Anthropomorphic Test Dummy; Six-Year Old Dummy

ACTION: Final rule; technical amendment.

SUMMARY: This document makes a minor correction to the thorax assembly and test procedure in NHTSA's regulation for the six-year-old child dummy. This document corrects inconsistencies between the figure in the regulation that illustrates the test set-up for calibrating the dummy's thorax and the regulatory text that describes the calibration test procedure. This action removes potential sources of concern and confusion for manufacturers and users of the dummy about whether a particular six-year-old child dummy meets the specifications of NHTSA's regulation for the dummy (part 572, subpart I).

**FIGURE 41
THORAX IMPACT TEST SET-UP**

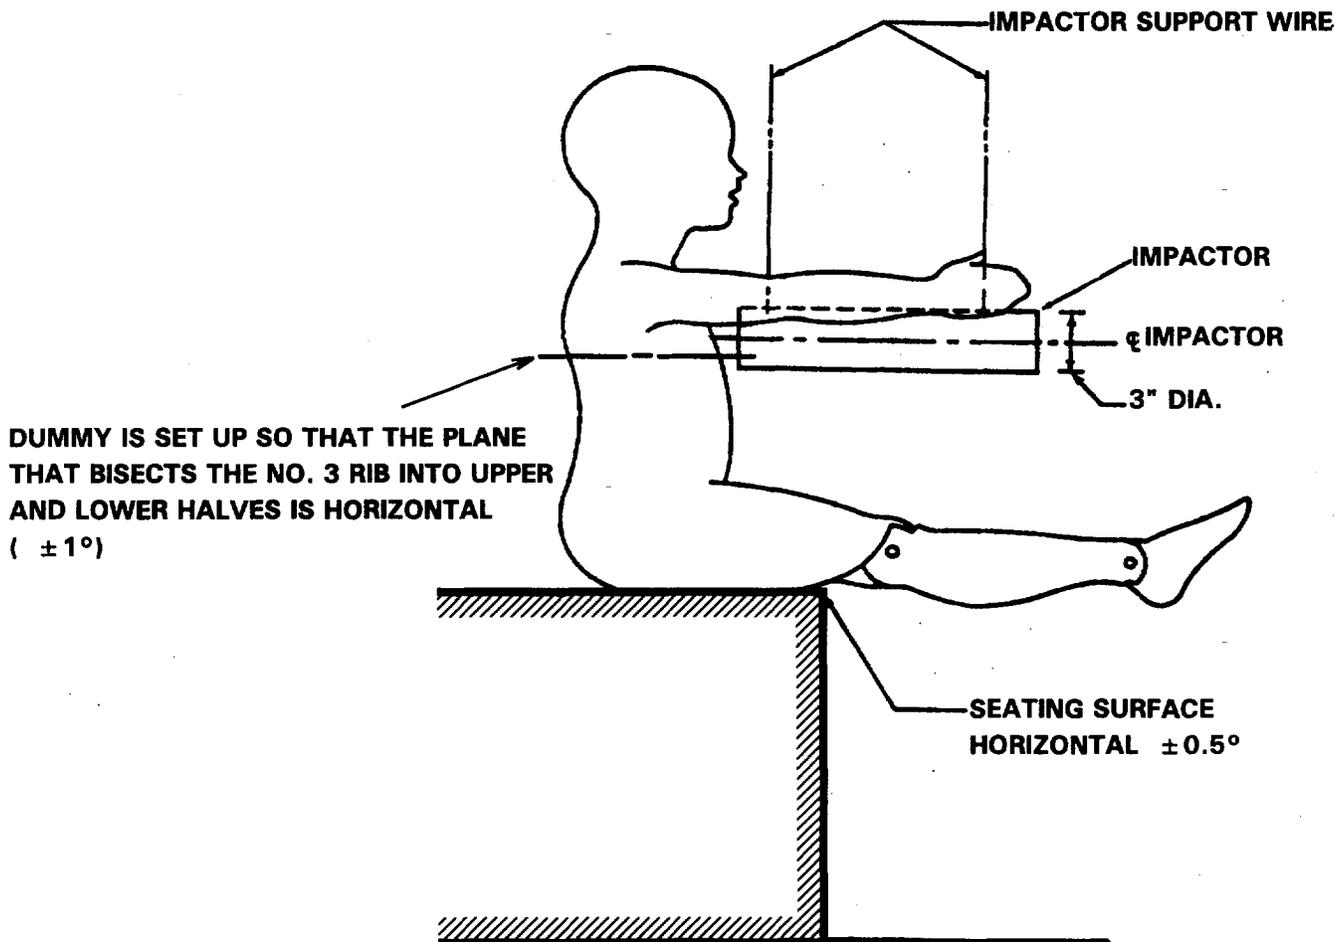
In February 1994, First Technology Safety Systems, Inc. (First Technology), a manufacturer of test dummies, informed the agency that figure 41 in subpart I appears to have two errors. Figure 41 illustrates the test set-up for calibrating the dummy's thorax (figure 41, "thorax impact test set-up"). Both errors are due to inconsistencies between figure 41 and the regulatory

The thorax test procedure [of section 572.74] states that the impact point should be 2.25 inches below the centerline of the clavicle retaining screw. The impact point based on that dimension would fall between the first and second rib. In contrast, figure 41 * * * shows the centerline of the impactor in line with the centerline of the third rib.

The second error relates to how the dummy is positioned for the thorax impact test. Section 572.74(c)(2) specifies that the dummy is adjusted "so that the longitudinal centerline of the No. 3 rib is horizontal." In contrast, an instruction in figure 41 specifies that the dummy is set up with the centerline of the number three rib horizontal " $\pm\frac{1}{2}$ [inch]." First Technology stated in its letter, "[T]he tolerance on figure 41 is $\pm\frac{1}{2}$ inch, which would result in 14 degrees variation."

NHTSA has examined First Technology's concerns and agrees that figure 41 and section 572.74 need to be amended so that they are consistent. As to the first error, the correct specification for the location of the impact point for the impactor is in section 572.74, and not in figure 41. The centerline of the impactor and the centerline of the third rib were drawn on figure 41 to be coincident instead of being slightly apart. This makes it appear that the impactor's first contact occurs at the centerline of the third rib, instead of approximately $\frac{1}{8}$ inch above it, in accordance with section 572.74. NHTSA is correcting figure 41 to depict the centerline for the thorax impactor as being slightly above the depicted centerline of the dummy's third rib.

As to the second error, the instruction in figure 41 that specifies that the dummy is "set up with centerline of #3 rib horizontal $\pm\frac{1}{2}$ inch" is inconsistent with the instruction in section 572.74(c)(2) concerning dummy set-up. The regulatory text states: "adjust the dummy so that the longitudinal

centerline of the No. 3 rib is horizontal." The " $\pm\frac{1}{2}$ inch" tolerance provided in figure 41 is inconsistent with the regulatory text since the centerline of the No. 3 rib of a dummy adjusted to the allowable limit could be far from horizontal. On the other hand, NHTSA believes that the tolerance should not be altogether eliminated. A 1 degree tolerance in section 572.74(c)(2) would provide some flexibility while ensuring that the centerline of the rib will be essentially, if not exactly, horizontal. Accordingly, NHTSA amends section 572.74(c)(2) to provide for ± 1 degree of tolerance. In addition, the instruction in figure 41 that specifies the dummy is "set up with centerline of #3 rib horizontal $\pm\frac{1}{2}$ inch" is revised to provide for the ± 1 degree of tolerance.

The regulatory text of section 572.74(c)(2) is also revised with regard to its reference to the "longitudinal centerline" of the No. 3 rib as the portion of the dummy that must be horizontal. Using the word "longitudinal" is inaccurate, since "longitudinal" describes a characteristic of a line, while what was actually meant was the alignment of the dummy in a plane. To more accurately describe the positioning of the dummy, the direction in section 572.74(c)(2) that the "longitudinal centerline of the No. 3 rib is horizontal" is changed to "the plane that bisects the No. 3 rib into upper and lower halves is horizontal" (± 1 degree). This text is also added to the instruction on positioning the dummy in figure 41.

(2) Establish the impact point at the chest midsagittal plane so that the impact point is 2.25 inches below the longitudinal center of the clavicle retainer screw, and adjust the dummy so that the plane that bisects the No. 3 rib into upper and lower halves is horizontal ± 1 degree.

3. Figure 41 in subpart I is revised to read as follows:
